Louisville and Jefferson County Metropolitan Sewer District
700 West Liberty Street
Louisville Kentucky 40203-1911
502-540-6000
www.msdlouky.org

Subject: I-64 and Grinstead Drive Storage Basin
Minor Project Modification
IOAP Project No. L_MI_MF_127_M_09B_B_A_8
DOJ Case No. 90-5-1-1-08254

MSD is requesting approval of a proposed minor project modification to the I-64 and Grinstead Drive Storage Basin project (IOAP Project No. L_MI_MF_127_M_09B_B_A_8). This request is a revision to the request provided in our letter dated September 20, 2012. This modification is part of the ongoing adaptive management review of the approved 2009 IOAP that has been documented in the 2012 IOAP Modification to be formally submitted in 2014.

2014 Project Modification Request

I-64 and Grinstead Drive Storage Basin

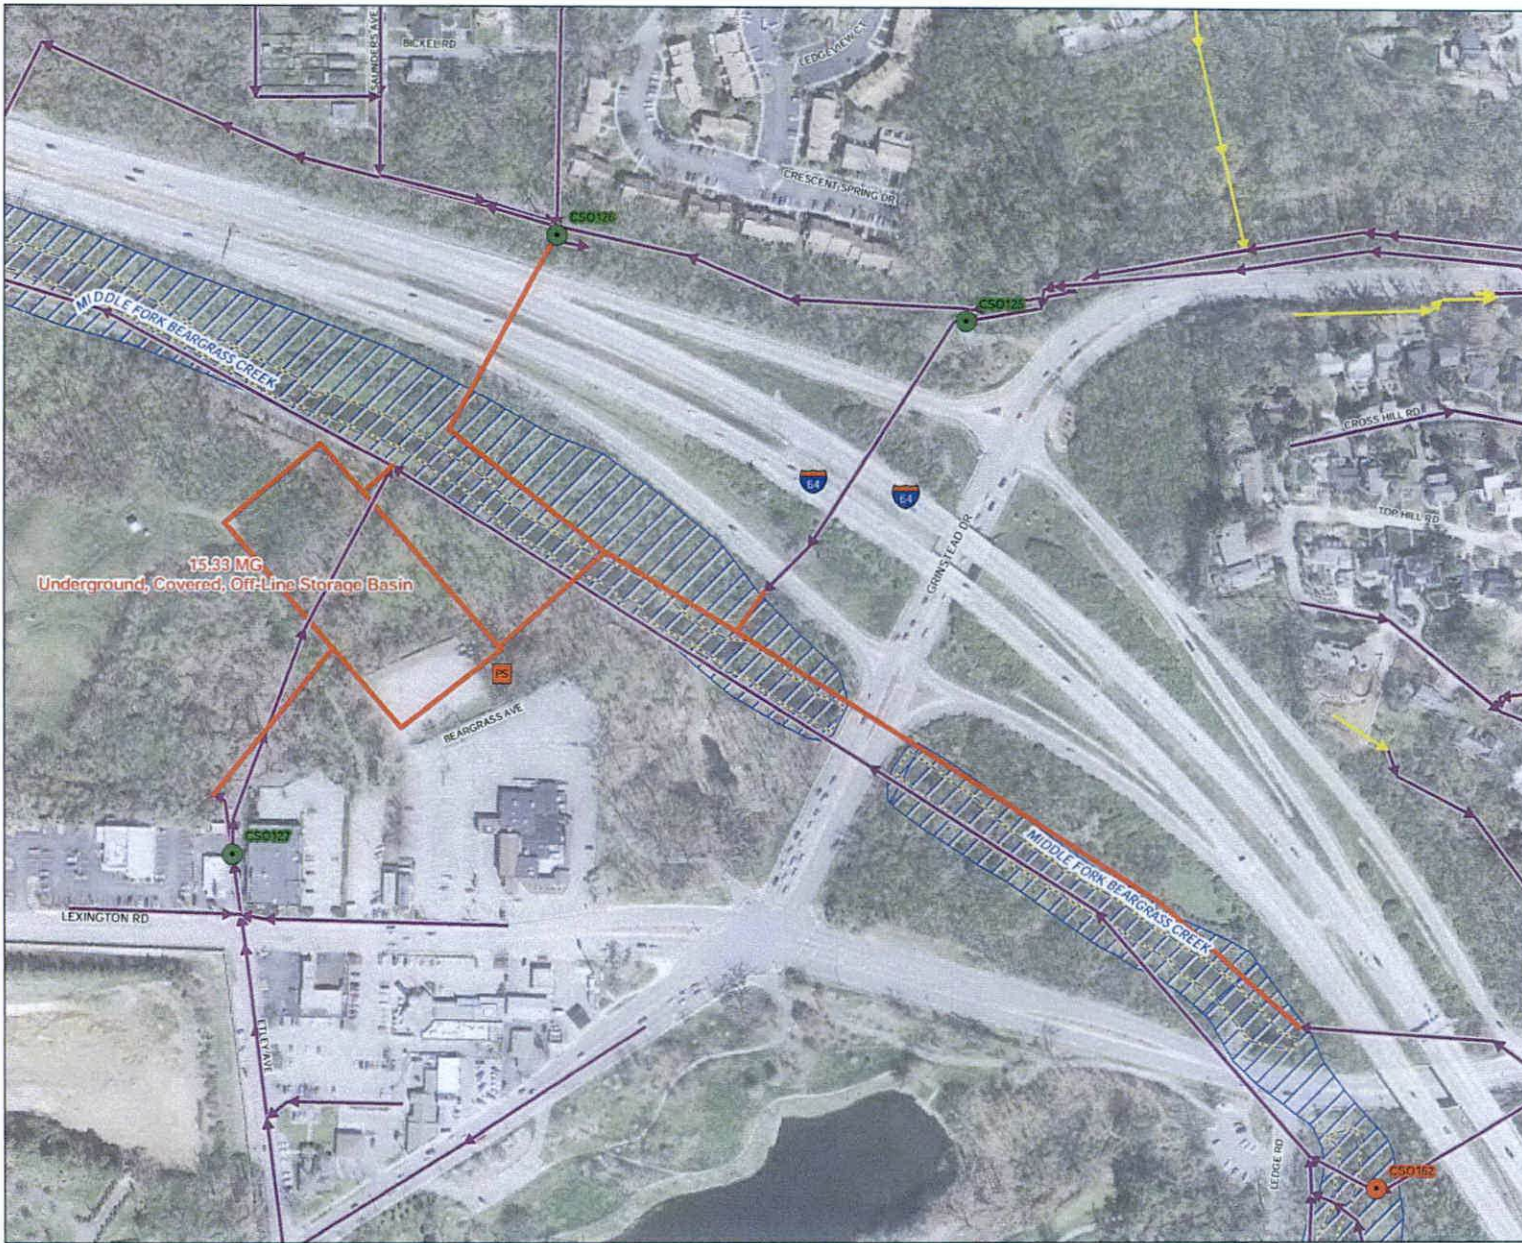
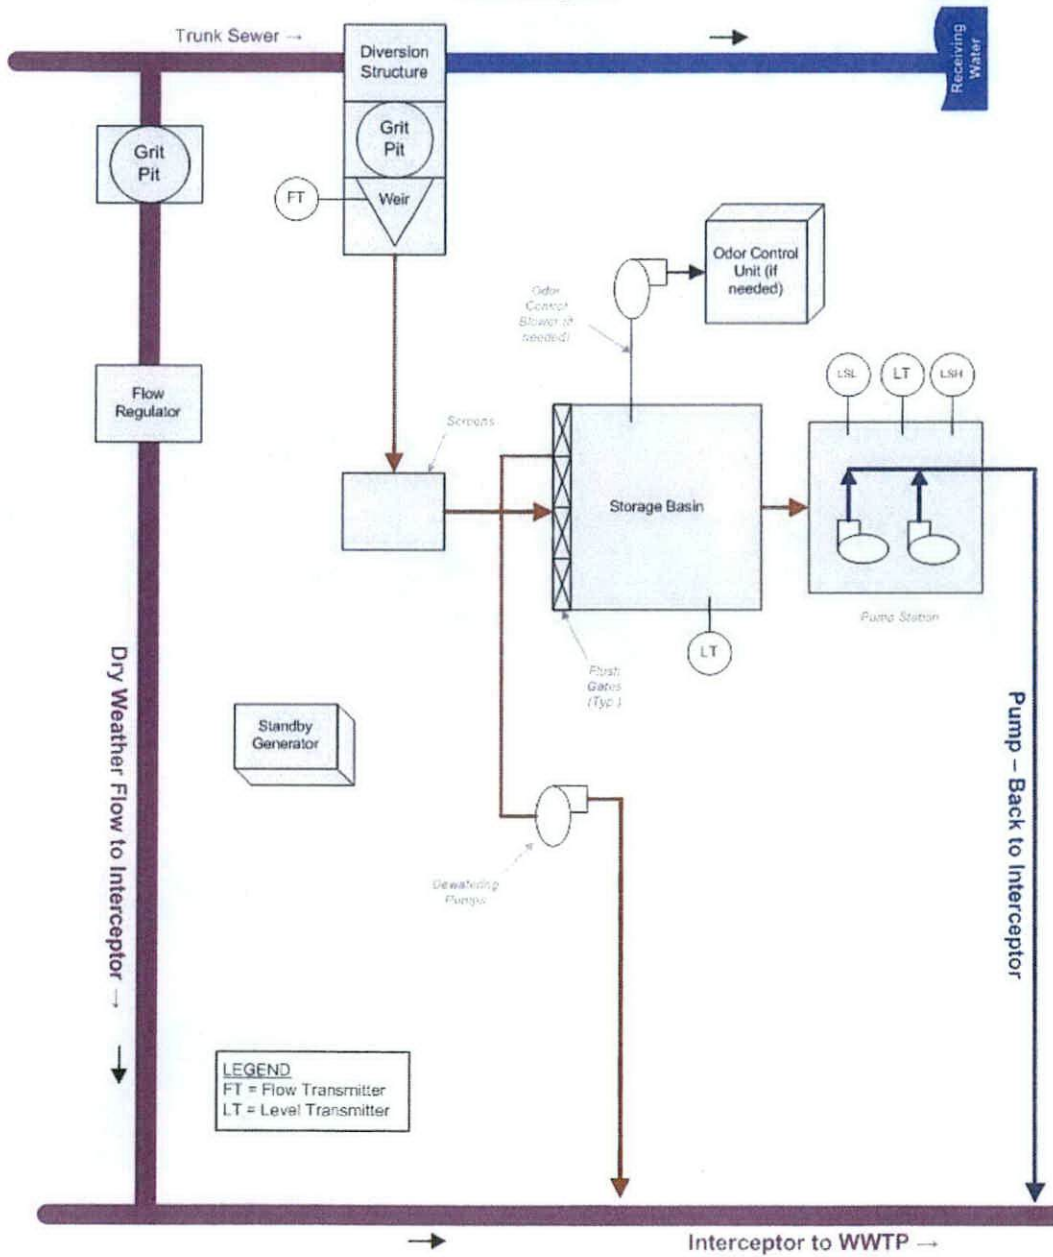
The project modification request includes adjusting the basin size to 8.5 million gallons and adding a stormwater interceptor line along Grinstead Drive, allowing disconnection of existing storm sewers that currently drain 123 acres and discharge into the combined sewer system. As further enhancements to the project, MSD proposes adding green infrastructure principles and stream restoration in the flood plain, performing downspout disconnections and sewer redirections of properties in the Kennedy Avenue area, and providing green infrastructure incentives for private property stormwater disconnections along Grinstead Drive.

A detailed evaluation of the basin identified a large area with separate stormwater systems discharging into the combined sewer system. Hydrologic and hydraulic modeling showed that these connections could be re-piped to discharge directly to surface water tributaries of Beargrass Creek, thereby reducing the basin size to 8.5 million gallons while still maintaining the 4 overflows per year level of control proposed in 2012. The evaluation also identified opportunities to increase the disconnection of downspouts, and

Project Description: This project is to provide a 8.5 MG off-line storage facility consisting of a covered concrete basin for CSO125, 126, 127 & 166 to reduce overflows to 4 overflows per typical year. The facility will be a gravity in-pump out operation. A significant stormwater diversion away from the combined sewer system is also proposed.
